## Ventura County Cultural Heritage Board Special Meeting Agenda

### OXNARD CULTURAL HERITAGE BOARD STAFF REPORT AND RECOMMENDATIONS AGENDA OF SEPTEMBER 15, 2011 ITEM NO. 4a

Oxnard 1981 Survey Area, 527 W. Fifth Street, Request for a Certificate of Review for New Construction of a Rear Residence over a Four-Car Garage, Renovation of Existing Front Residence and Removal of a Palm Tree, Project No. 11-355

Oxnard 1981 Survey Area, 226 W Magnolia Avenue, Request for a Certificate of Review for New Construction of Rear Addition to Existing Single Family Residence and Proposed Two Car Garage, Project No. 11-356

SHEET CONTENT: (E)UNIT 'A' ELEVATIONS
	DRAWN BY: A. BARRAGAN
	SCALE: AS SHOWN NO. A-4
	DATE: 8/11/11

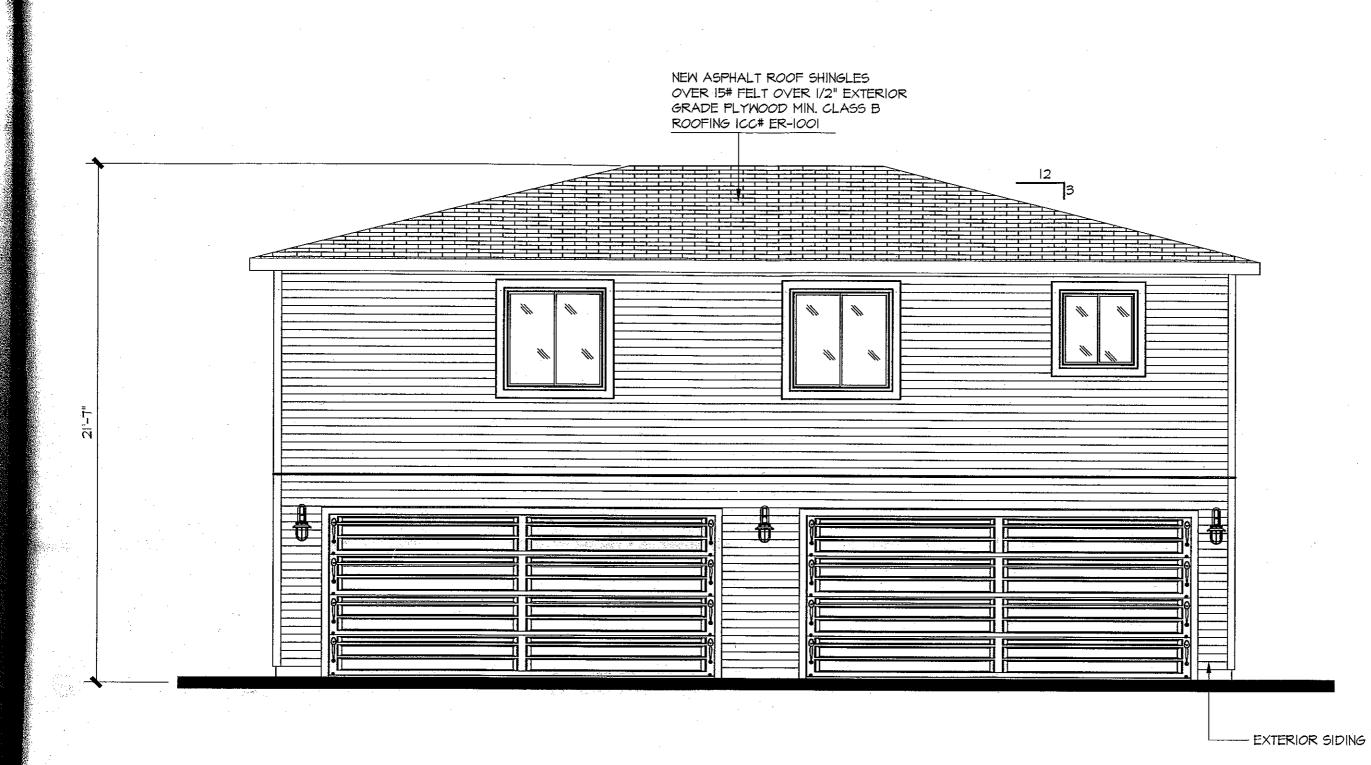
<u>Front Residence Renovation</u>: The proposed renovation of the existing front residence would repair, protect, and maintain those architectural features located on the front of the existing residence that faces Fifth Street consistent with the <u>Standards</u> (Number 9). However, staff finds that the replacement of the existing front residence's side and rear wood windows with vinyl sliders and the replacement of the clapboard siding along the east and west (side) elevations with stucco siding are inconsistent with the <u>Standards</u> (Number 5).

These proposed rear and side windows are not of historic materials or design. Staff recommends the applicant provide double or single hung windows that match the appearance, size, design, proportion and profile of the existing historic windows and repair and maintain the existing narrow clapboard siding.

:		
	(		• •
	NEW ASPHALT ROOF SHINGLES OVER 15# FELT OVER 1/2" EXTERIOR GRADE PLYWOOD MIN. CLASS B	2	
	ROOFING ICC# ER-1001	-	
		12	···· .
	[]		
	11 11		
	······		
	- 7/8" STUCCO 0/		
EAST ELEVATION	2-15# FELT (TYP. @ EXT.		EXTERIOR SIDING
	(WALLS)	Exhibit 4e

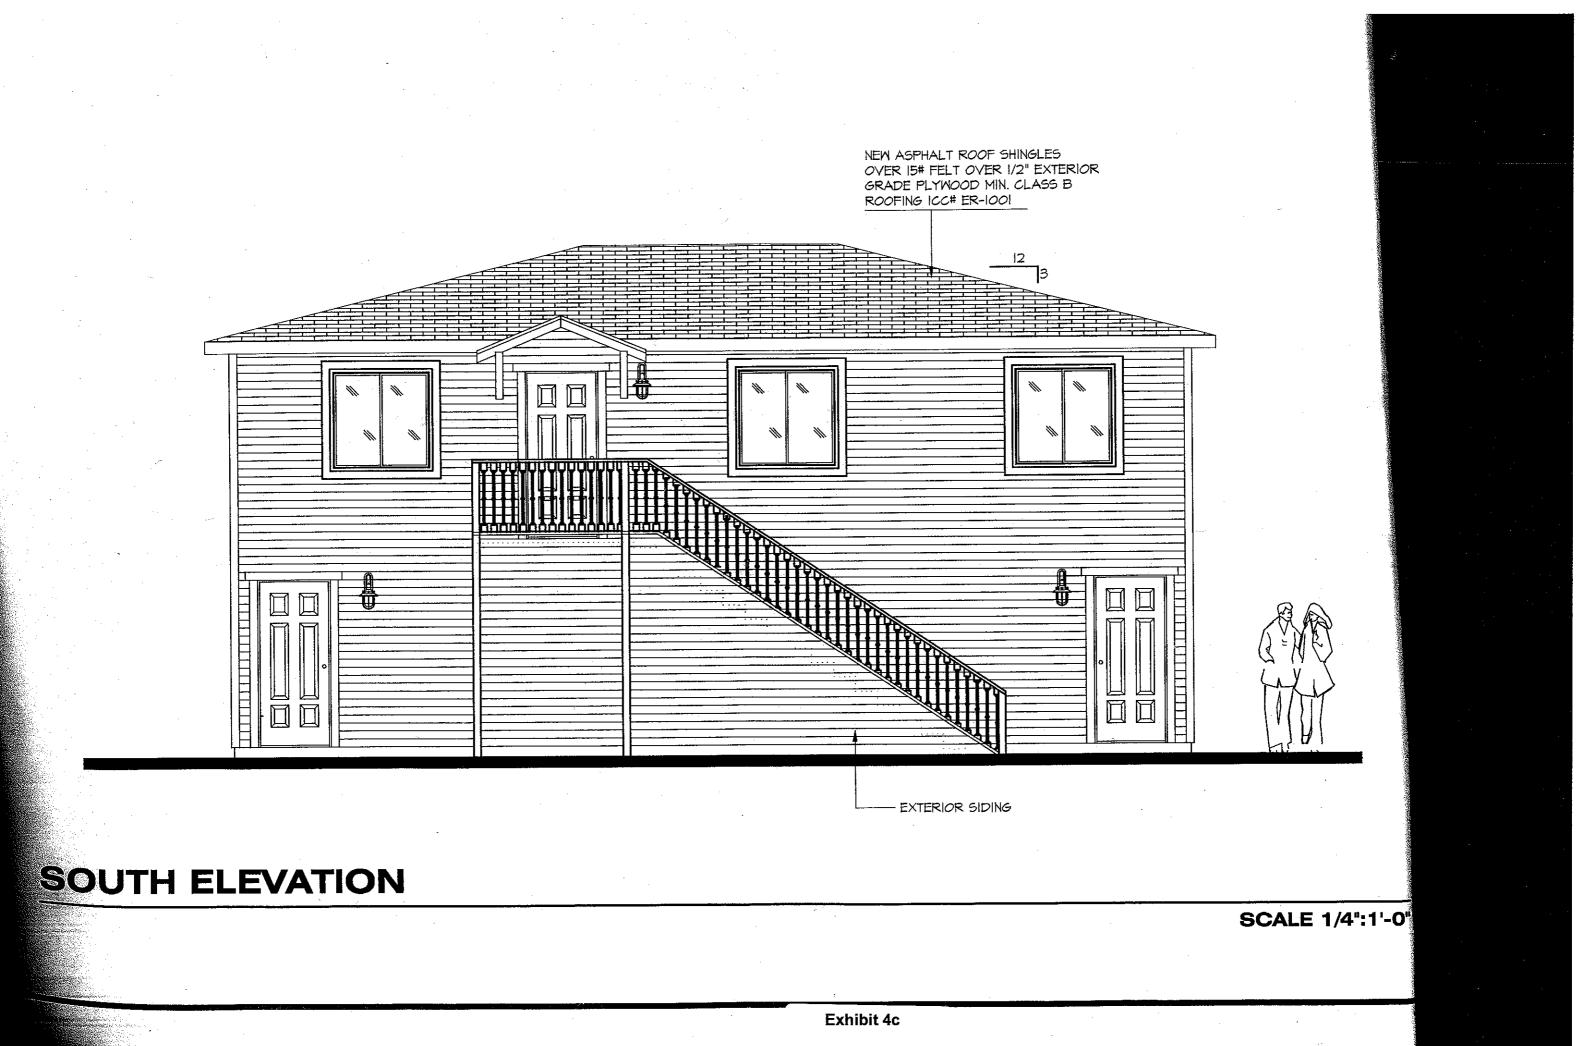
<u>Proposed Rear Residence and Four Car Garage:</u> The new residence above the proposed four car garage would be located in the rear of the property. The massing and height of the garage and dwelling addition above appear to be acceptable given the site conditions and the distance from the rear structure and Fifth Street. The new addition will be visible to a small degree when the home is viewed obliquely from the east.

Staff finds that the proposed rear residence's vinyl slider windows would be considered inconsistent with the Secretary of the Interior's Standards for Rehabilitation (<u>Standards</u>) Number 9 as it would be incompatible with the existing historic neighborhood.

Staff recommends the Board provide comment that the property owner should install compatible and energy-efficient replacement windows that match the appearance, size, design, proportion and profile of the existing historic windows and add detailing to the new residence.

<sup>2760</sup> MAPADIA ANG - EXICTING WINDOWS

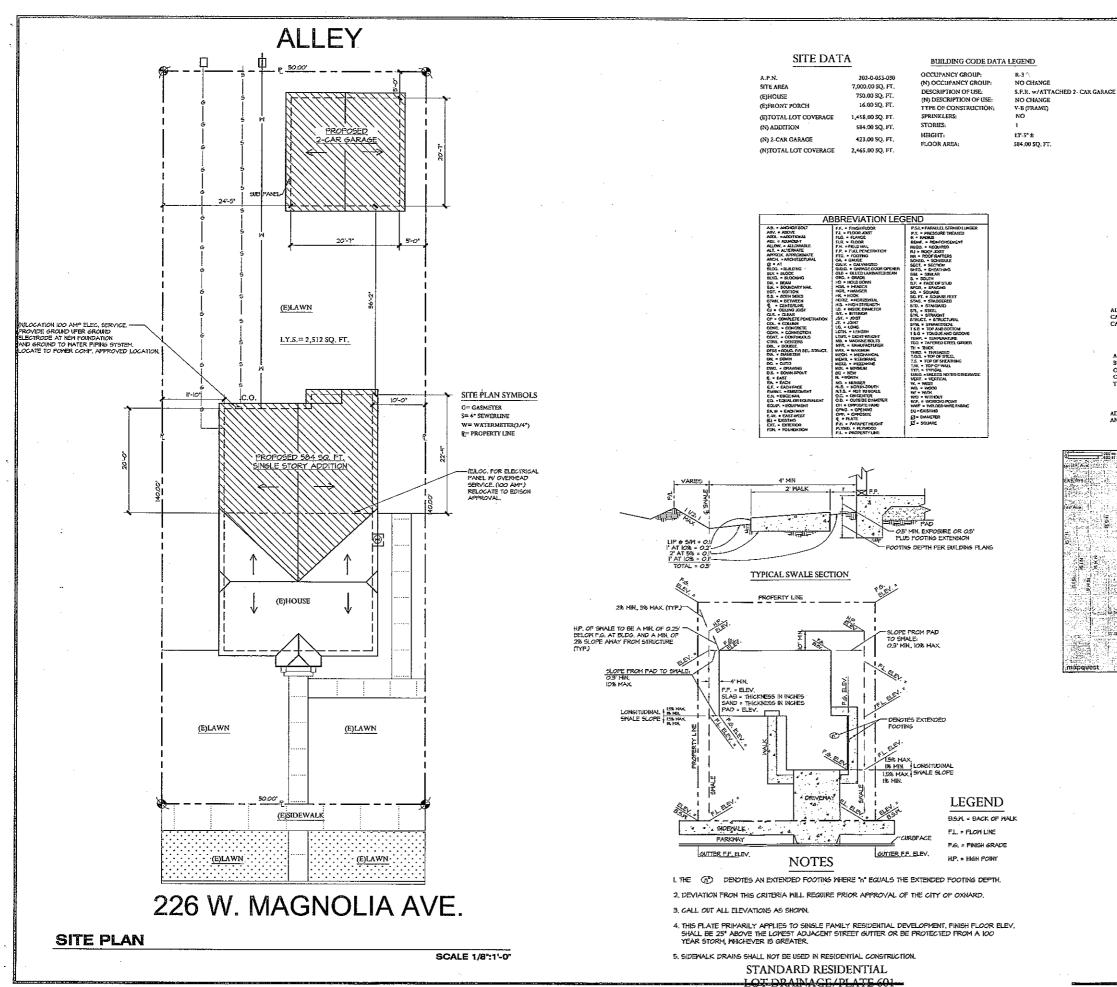
<u>Residence Renovation</u>: The proposed renovation of the existing front residence would repair, protect, and maintain those architectural features located on the front of the existing residence that faces Fifth Street consistent with the <u>Standards</u> (Number 9). However, staff finds that the replacement of the existing residence's wood windows with vinyl single hung windows is inconsistent with the <u>Standards</u> (Number 5).

Staff recommends the Board provide comment that the property owner should install double or single hung windows that match the appearance, size, design, proportion, material and profile of the existing historic windows.

Exhibit 5b

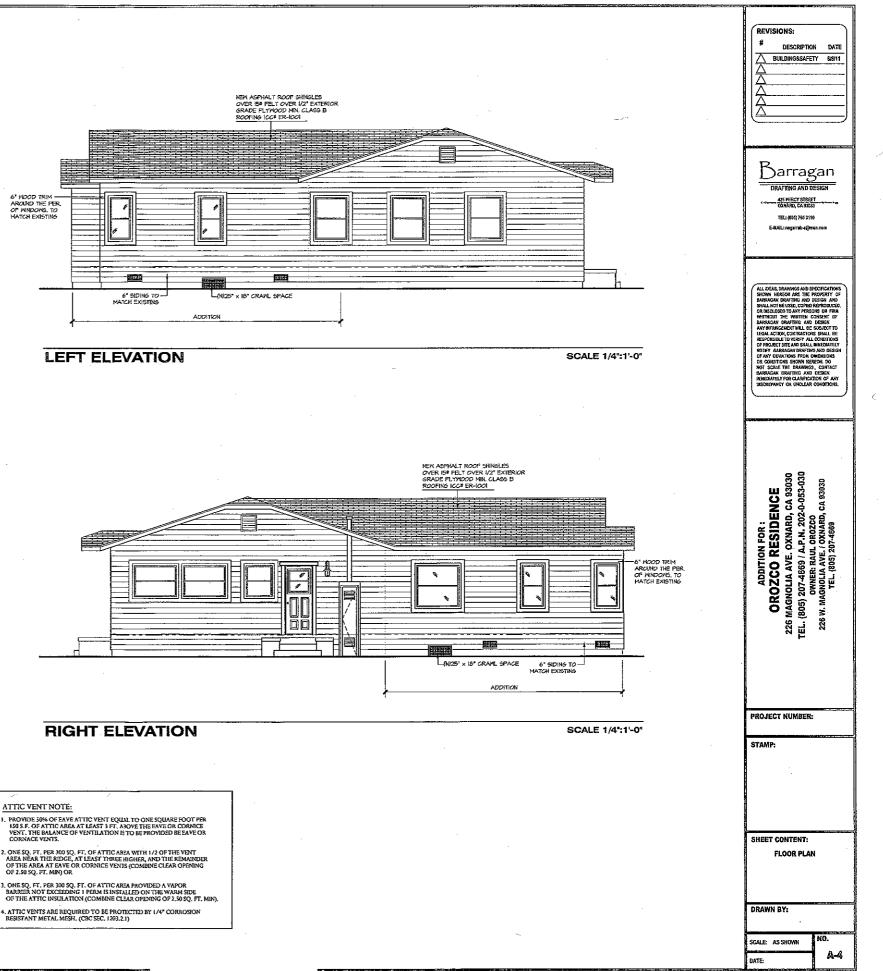
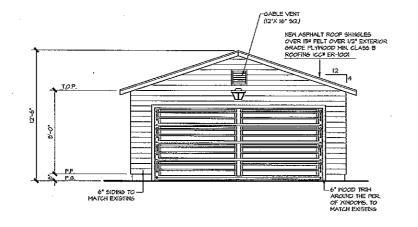
<u>Proposed Addition and Two Car Garage:</u> The massing and height of the garage and addition appear to be acceptable given the site conditions and the distance from the rear addition and Magnolia Avenue. The new addition may be visible to a small degree when the home is viewed obliquely from the east and west.

Staff finds that the proposed vinyl single hung windows in the new addition are inconsistent with the Secretary of the Interior's Standards for Rehabilitation (<u>Standards</u>) Number 9. To preserve the integrity of the structure, the new windows should match the existing wood windows.

Staff recommends the Board provide comment that the property owner should install compatible and energy-efficient replacement windows that match the appearance, size, design, proportion, material, and profile of the existing historic windows.
